**Additional North Dakota Game and Fish  
Correspondence**

**Badger Wind Farm Impacts Analysis and Offset Estimates**  
North Dakota Game and Fish Department

RE: Badger Wind Project, Logan and McIntosh counties, North Dakota

19 PU-22-86 Filed 06/01/2022 Pages: 23  
Agency Correspondence  
North Dakota Game & Fish Department  
Greg Link, Chief

Figure 1. Results of NDGF local grassland assessment.

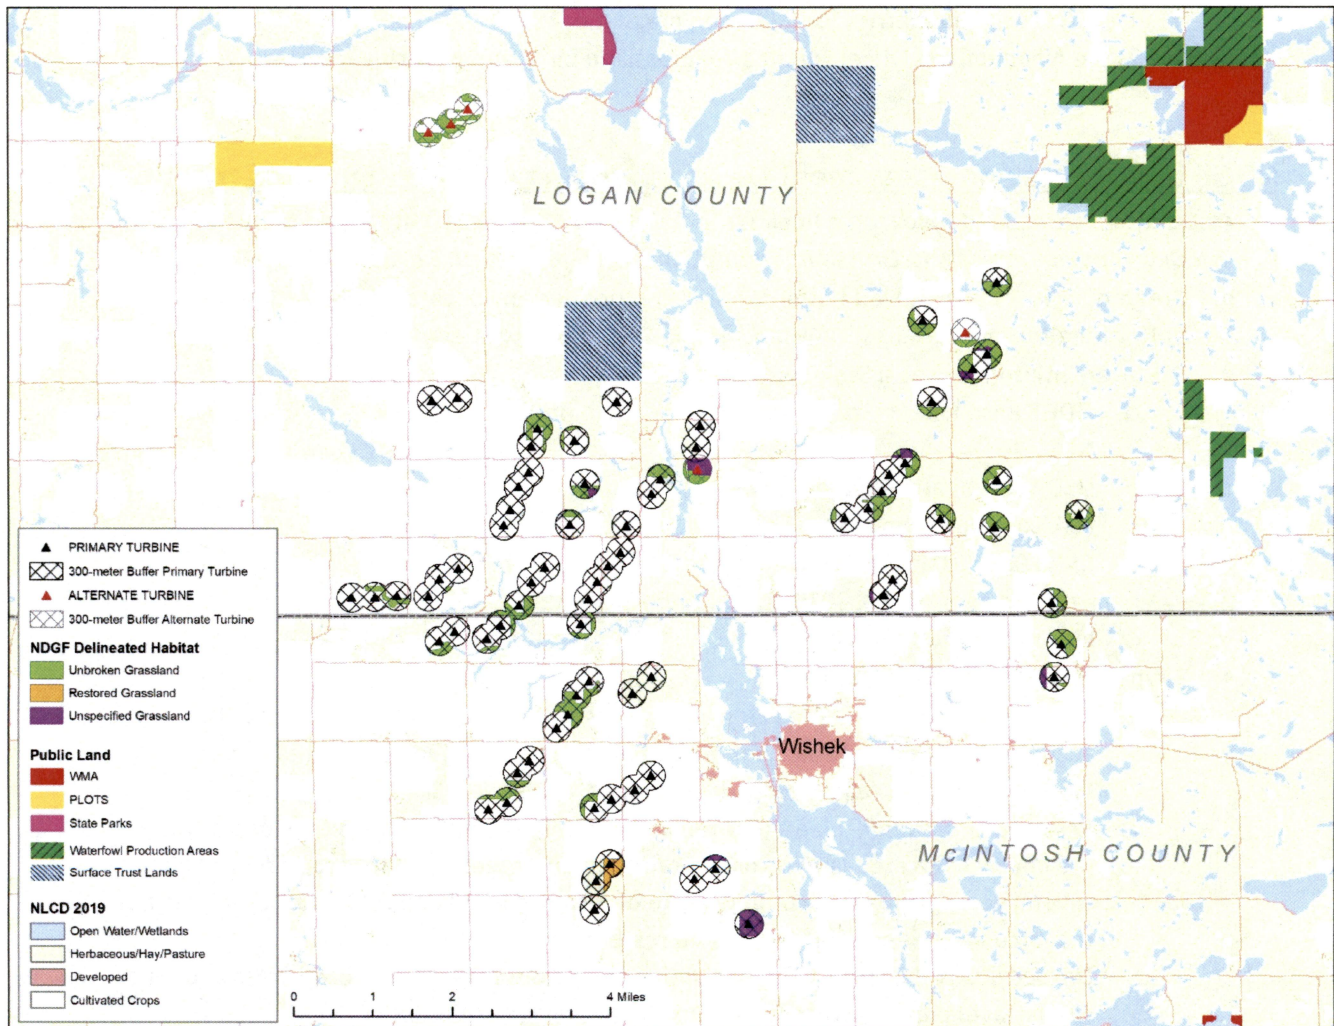
- **Acres of unbroken grassland impacted = 758.8**
    - **Offset acres = 402.2** (total unbroken X 53% displacement)
  - Additional acres of restored grassland impacted = 43.4 (offset = 23.0 acres)

- Additional acres of unspecified grassland impacted = 123.5 (offset = 65.5 acres)
  - 1 turbine sited on unbroken grassland
  - 2 additional turbines sited on restored or unspecified grassland

- 2 additional turbines within 50 feet of grassland
- Results for Alternate Turbines

- **Acres of unbroken grassland impacted = 113.2**
  - **Offset acres = 60 (total unbroken X 53% displacement)**
- **Additional acres of unspecified grassland impact = 39.0 (offset = 20.7)**
- **1 turbine sited on unspecified grassland**
- **2 additional turbines sited within 50 feet of grassland**

Attachment 3. Chestnut-collared Longspur Model with original project boundary

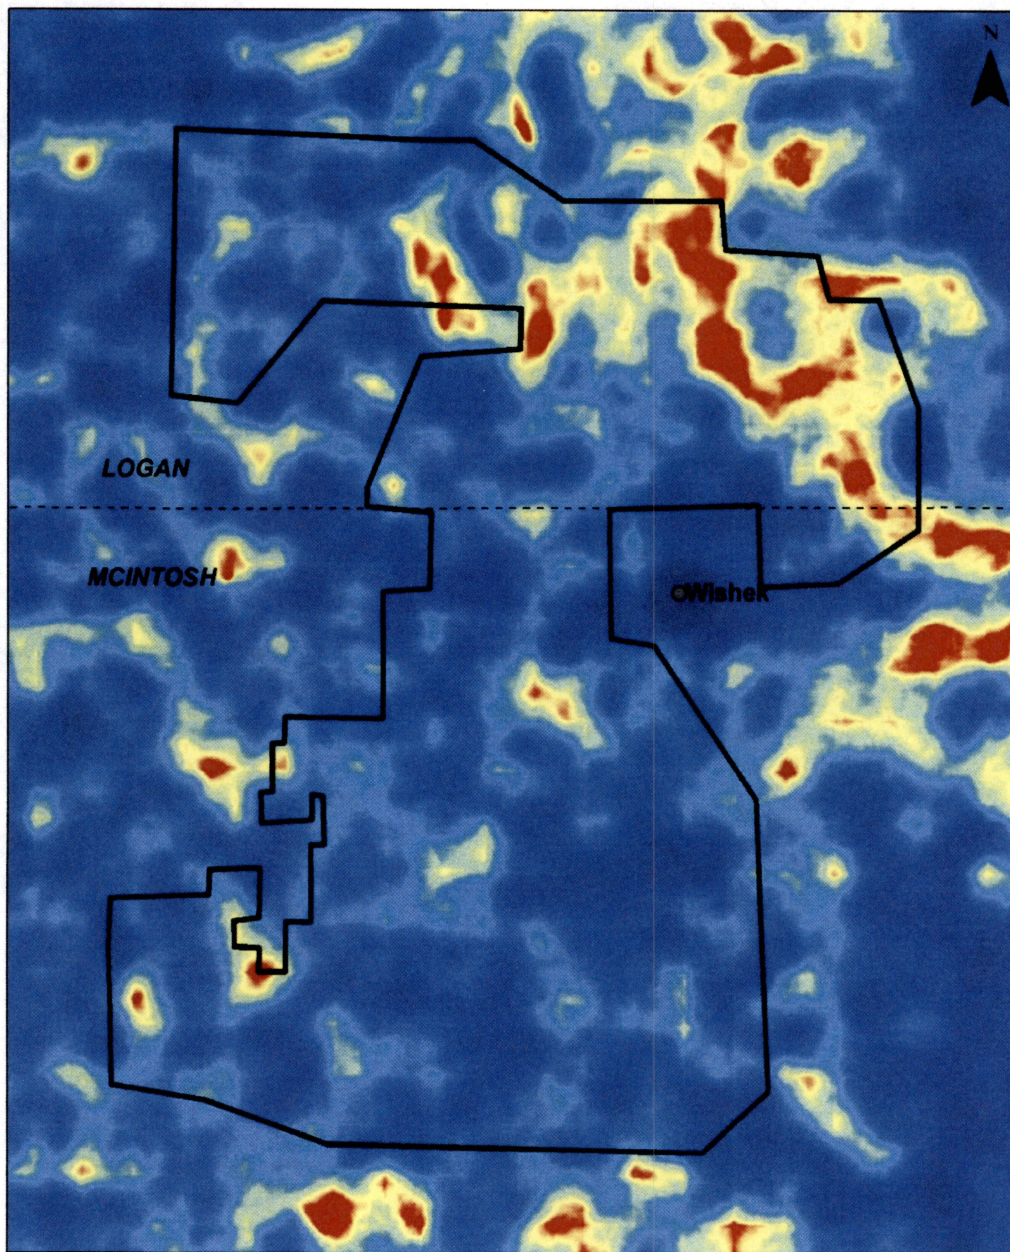
The North Dakota Game and Fish Department (Department) first learned of the proposed Badger Wind Project in early 2020. Many of the early discussions on the project centered around the Department’s serious concerns of the project boundary (Guidance Letter, Attachment 1). The area, specifically the northern part, has a considerable amount of unbroken, native prairie (Attachment 2). This habitat is essential for many rare and declining species, such as grassland dependent birds. These birds, our ‘canaries in the coal mine’, have shown “steeper, more consistent, and more geographically widespread declines than any other behavioral or ecological guild” (Knopf 1994). Breeding Bird Survey data collected from 1966-2015 show the state’s bird, the Western Meadowlark, declines approximately 1.25% each year. Once abundant throughout the state, the Western Meadowlark has lost over half of its population in North Dakota and is now considered rare in the eastern counties. Another example, the Chestnut-collared Longspur, has decreased by 86% since 1974 (Rosenberg et al. 2016) and is listed as a Species of Conservation Priority in the North Dakota State Wildlife Action Plan (Dyke et. al 2015) and is on the IUCN Red List as Vulnerable and is considered globally threatened. In 2020, the project layout provided to the Department had over 20 turbines being placed in unbroken prairie crucial to Longspurs in North Dakota (Attachment 3 & 4).

Attachment 6. Final turbine layout and habitat delineation

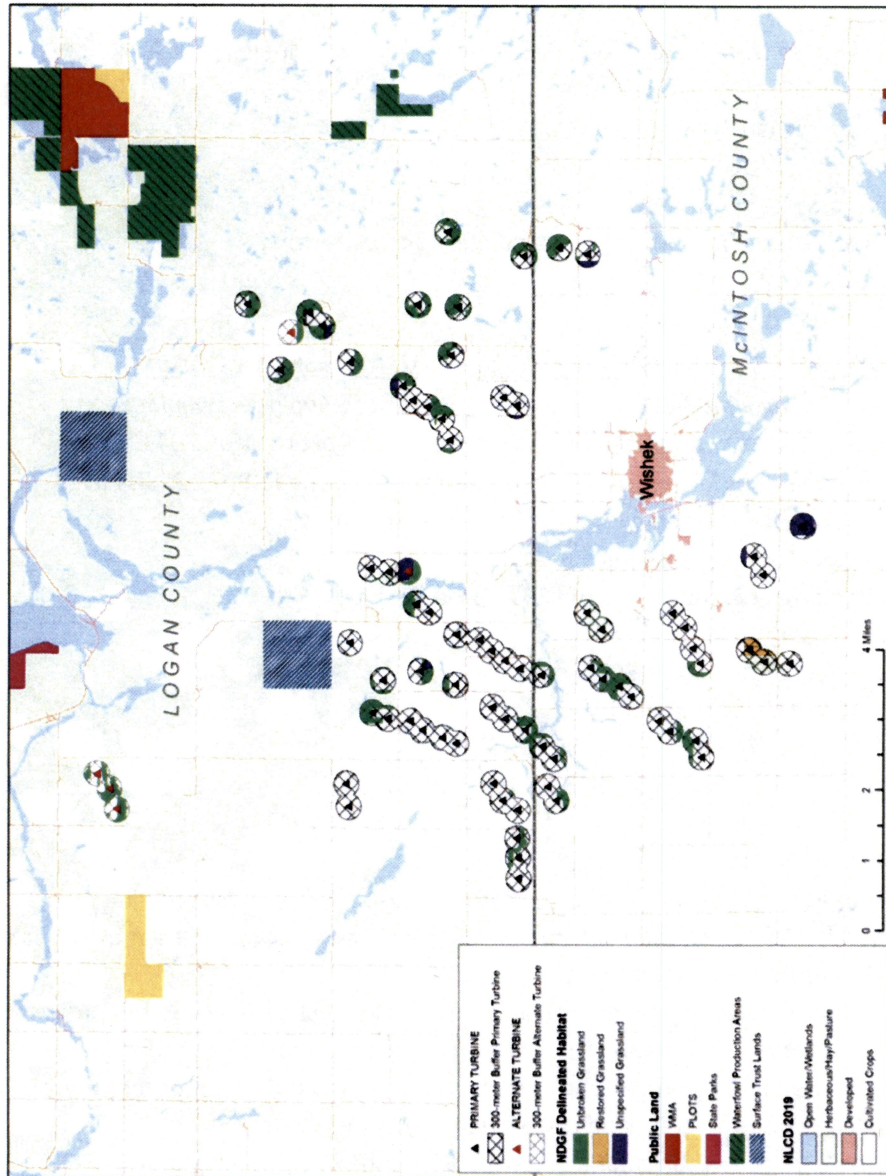
In February of this year, Badger provided an updated turbine layout. This new turbine layout is a great improvement from the original layout, with many turbines moved away from areas of important habitat. However, because the site originally selected for the project fell partially within a resource rich and sensitive area (Attachment 5a & 5b) and surrounded a vast amount of native habitats (both grasslands and wetlands), even with the changes made there are likely to be significant impacts to wildlife and the habitats they depend on (Attachment 6).
